TOLEDO - LUCAS COUNTY PLAN COMMISSIONS

REF: PUD-8009-22

SUBJECT: Planned Unit Development for multi-family development at 1338 N. Summit

SITE PLAN

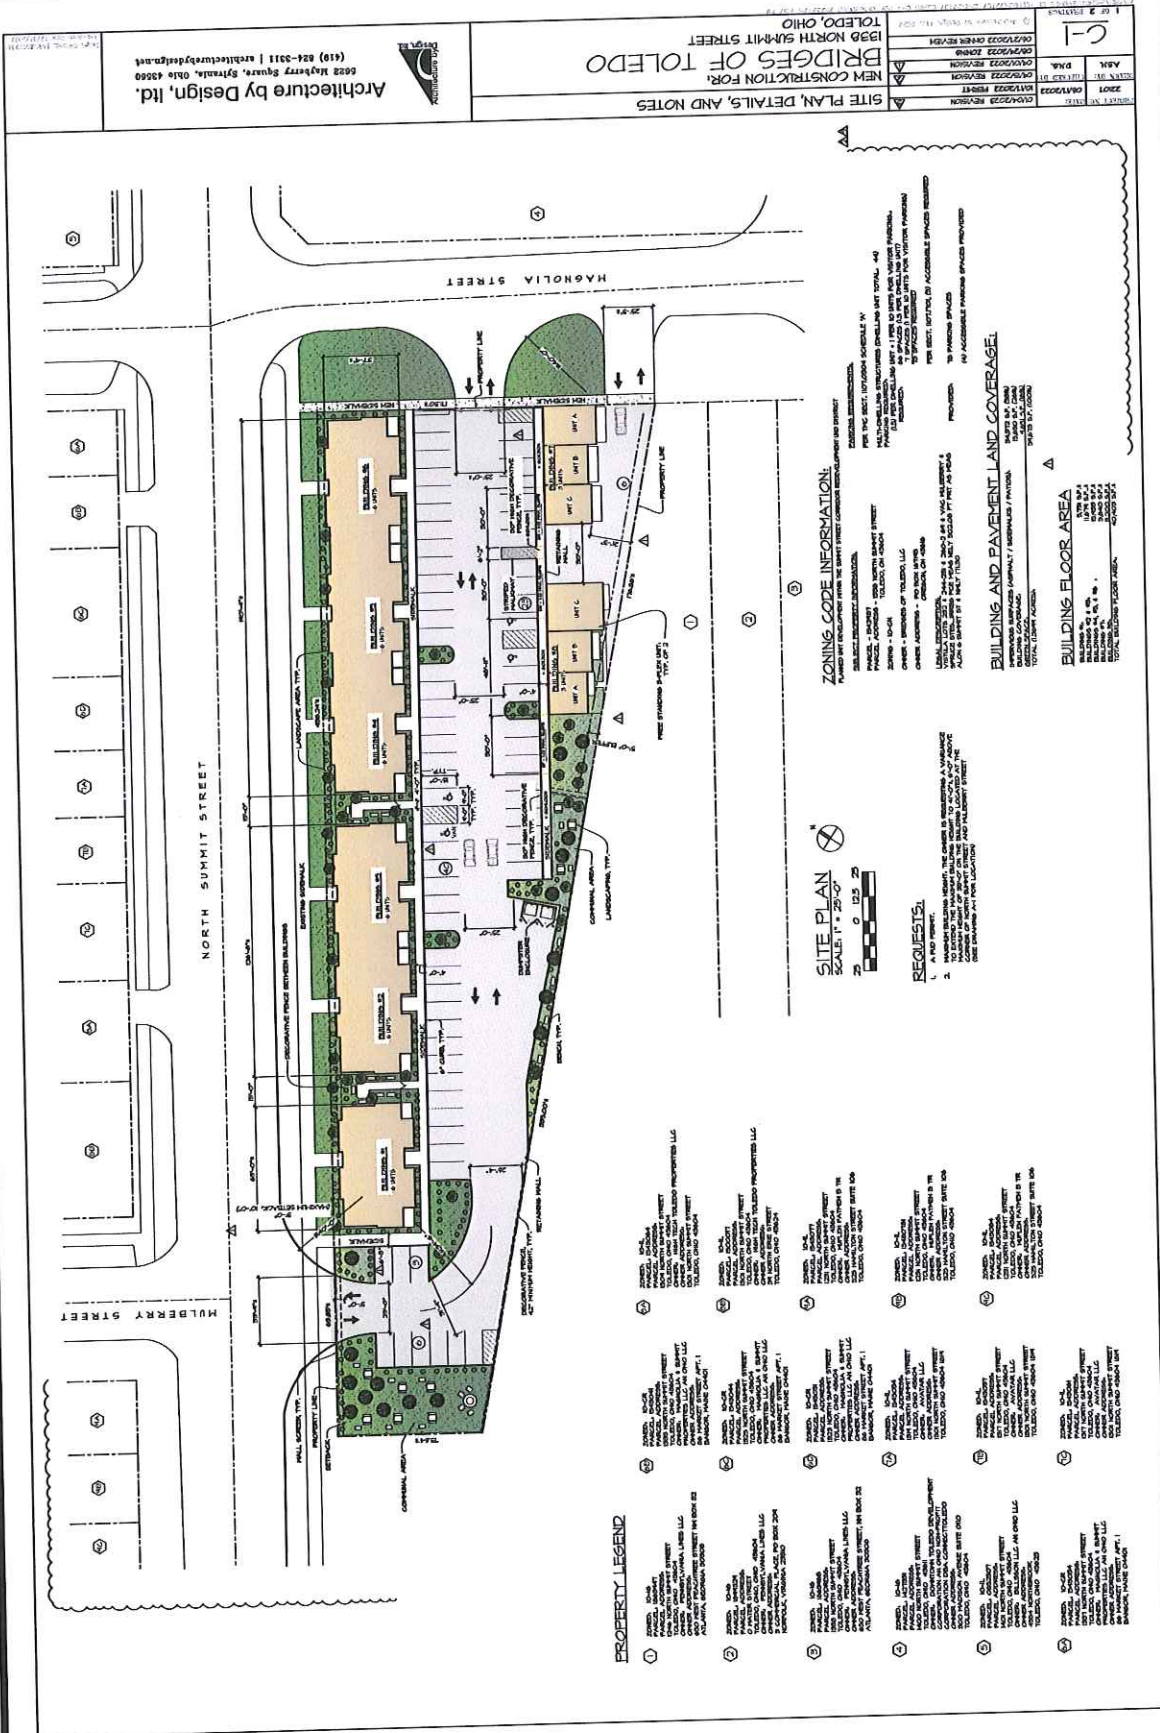
38. The maximum building setback is ten-feet (10') along Summit Street. **Acceptable as depicted.**
39. Bicycle parking slots shall be provided pursuant to Off-Street Parking Schedule "A" (TMC§1107.0300). One bicycle parking slot shall be provided per every ten (10) parking spaces for a total of seven (7) spots. Given the urban context of the site and proximity to bicycle trails, the applicant is encouraged to include additional bicycle parking required beyond the minimum. **None depicted. Seven (7) spaces shall be shown on a revised plan.**

- a. Any part of the lot area not used for buildings, other structures, or for roads, walks, parking, service areas or accessways must be landscaped with a combination of groundcover, trees, and shrubs. Grass may be used in conjunction other plan material. **Plantings depicted on site plan are acceptable as depicted.**

- b. Landscape improvements must be provided in the sidewalk or other paved area in front the building. One understory street tree for every 30 feet of frontage shall be provided along Magnolia. Such plantings may be in the right-of-way pursuant to TMC§1108.0303. **None depicted.**

- c. Perimeter landscaping must be installed along any parking lot area adjacent to the street. Said landscaping shall include a five-foot wide planted area with at least one shrub for every 3 to 5 feet, a 3.5 ft high metal tube fence or solid bar fence, with at least on shrub for every 3 feet of property line planted outside of the fence, or a solid 3.5 foot high brick or stone wall. Such screening methods shall be used along Magnolia and Summit. **None depicted.**

SOUTH ELEVATION (MAUMEE RIVER)
SCALE: 1/8" = 1'-0"

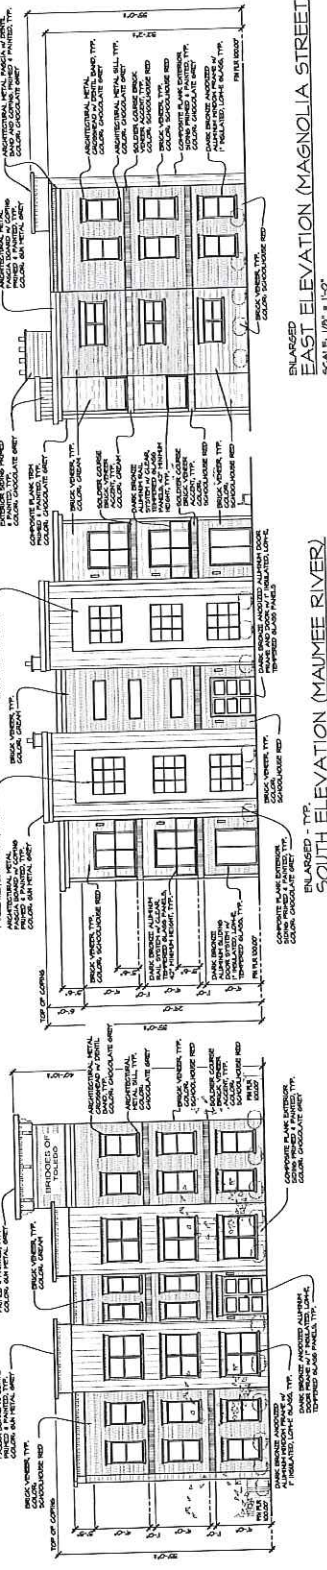
- b. East and West elevations depict 62% Brick, 8% Composite Plank, 13% Architectural Metal, 17% Fenestration. **Acceptable as depicted.**
 - c. South elevations depict 26% Brick, 22% Composite Plank, 22% Architectural Metal, 30% Fenestration. **Composite plank shall be reduced below 20% or a waiver shall be obtained.**

Approve a waiver to not require eighty percent (80%) predominant materials along the southern façade, and allow for the use of twenty-two percent (22%) composite on the southern elevation. The applicant and architect have worked with staff to create a visually appealing design which satisfactorily meets the intent of the Zoning Code.
